## Staff Data Requests

### J. Zanesville Energy, LLC, Case No. 14-2254-EL-REN

Summary: Reply electronically filed by Mr. Bruce Bailey on behalf of Zanesville Energy, LLC

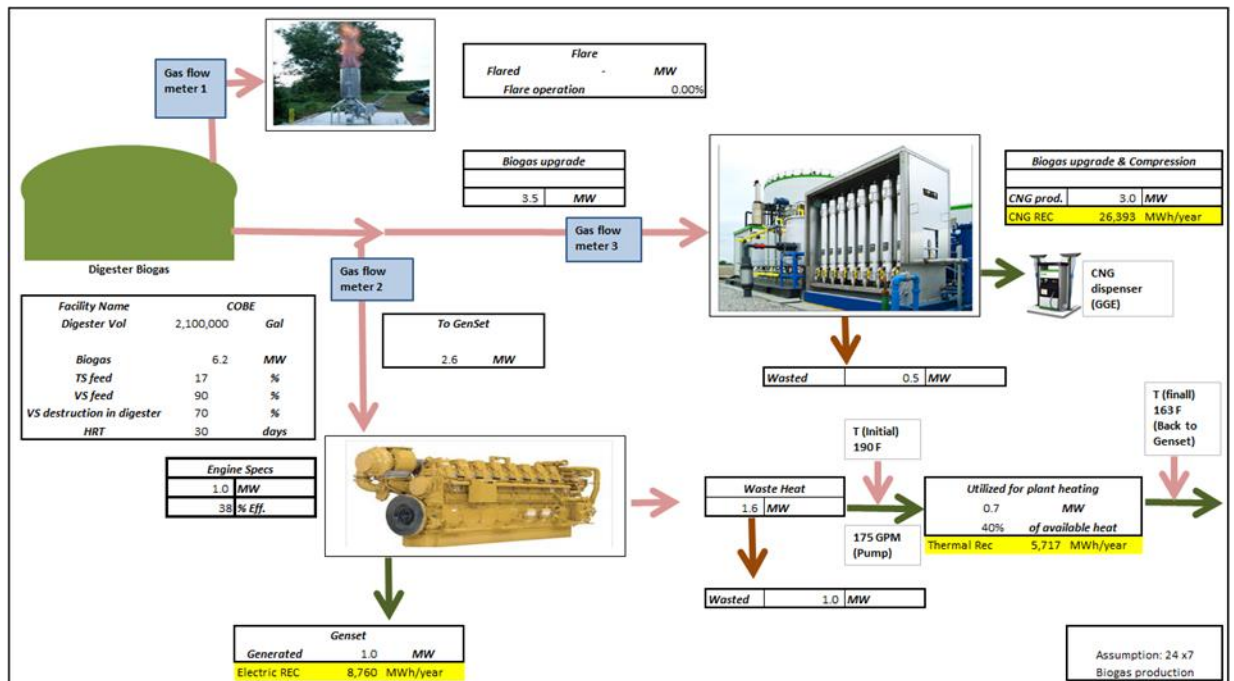
12. Regarding Section G.3 of the application, please provide a detailed description of how heat captured by each source is going to be measured and verified, including the configuration of the meter(s), the meter types(s), and meter accuracy. What is the projected in-service date of the thermal meters? Please provide documentation.

**Thermal REC:** Engine is cooled using a heat loop which circulates Glycol-Water mixture (50%) across the plant. The flow of the glycol is **175 GPM** (Pump rating, see fig.).

We have temperature sensor located in the engine which show the temperature of glycol taking waste heat from the engine. **The temperature is typically around 190° F (See fig. 1)** This glycol flows in the plant supplying heat for plant purpose (Digester heating, Floor heating, Pasteurization). **The return temperature of glycol is around 163° F (See fig. 1)**
